Service Bulletin

Bulletin No.: 17-NA-097

Subject: Side Blind Zone is Not Working Correctly and/or Incorrect Side Mirror Notification

Brand:	Model:	Model Year:		VIN:		Engine:	Transmission:
		from	to	from	to		
Chevrolet	Bolt EV	2017	2021	—	—	—	—
Opel/ Vauxhall	Ampera-e		2019

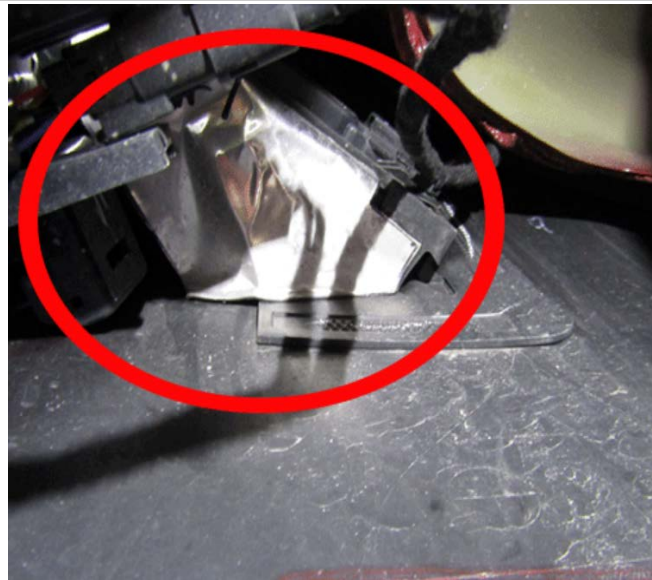
Involved Region or Country	North America, Europe, GM Korea Company, Middle East
Additional Options (RPOs)	Equipped with Side Active Safety Obstacle Detection Enhanced (RPO UKC)
Condition	<p>Some customers may comment when driving, the side mirror indicates there is a vehicle present when there actually is not.</p> <p>Technicians may find one or more of the following conditions:</p> <ul style="list-style-type: none"> • Wiring harness to the sensors may not be properly connected or routed. • Butyl tape not covering the sensor bracket completely. • Butyl tape missing completely.
Cause	<p>If the side blind zone has been found not working properly, inspect one or more of the following areas:</p> <ul style="list-style-type: none"> • Butyl tape application at the sensor brackets. • Sensor harness electrical connection and routing. • Poor grounding at the G401 and/or G404 body ground.
Correction 1	<div style="text-align: center;">  </div> <p style="text-align: right; font-size: small;">4749843</p> <p>Inspect the wiring harness electrical connectors for proper connections and routing.</p>

Correction 2

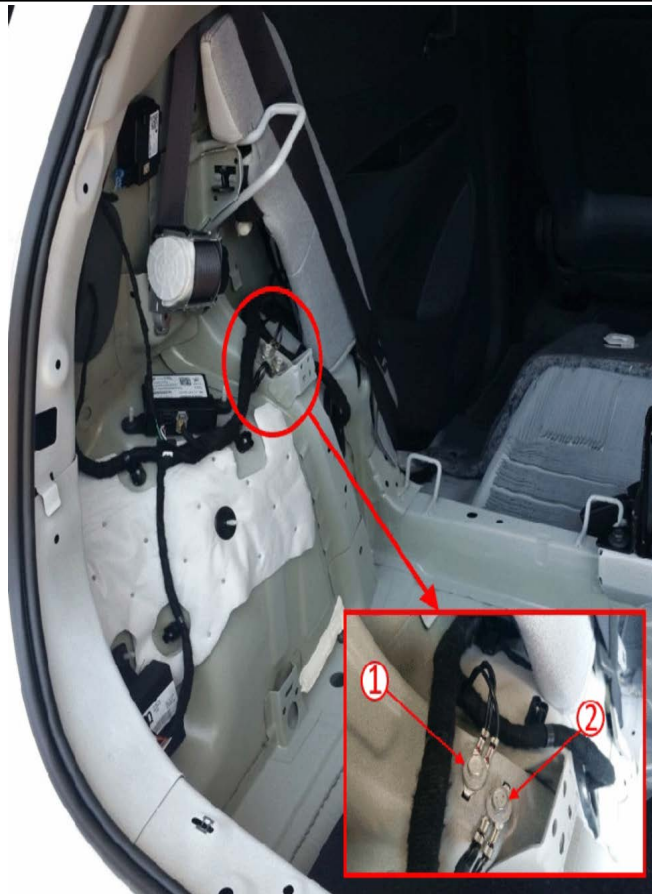
Important: The opening must be completely covered with the butyl tape to avoid allowing unwanted radar reflection to be detected and triggering the false alerts. Install a new single piece of aluminum butyl tape on the bottom of the object sensing alert module brackets so the opening is completely covered by the tape.

Correction 3

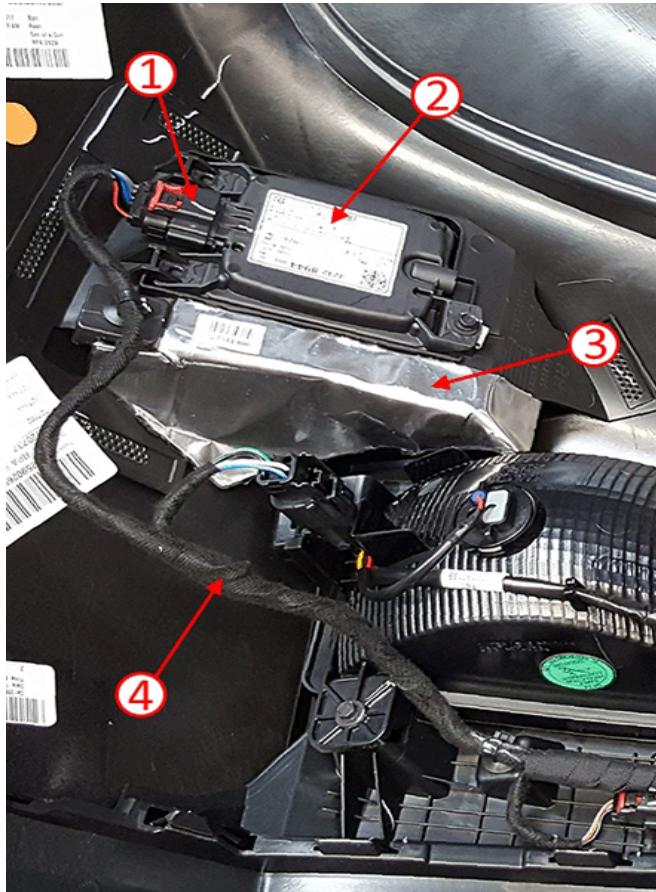
Remove the G401 (2) and G404 (1) grounds. Clean and remove paint from contact points.
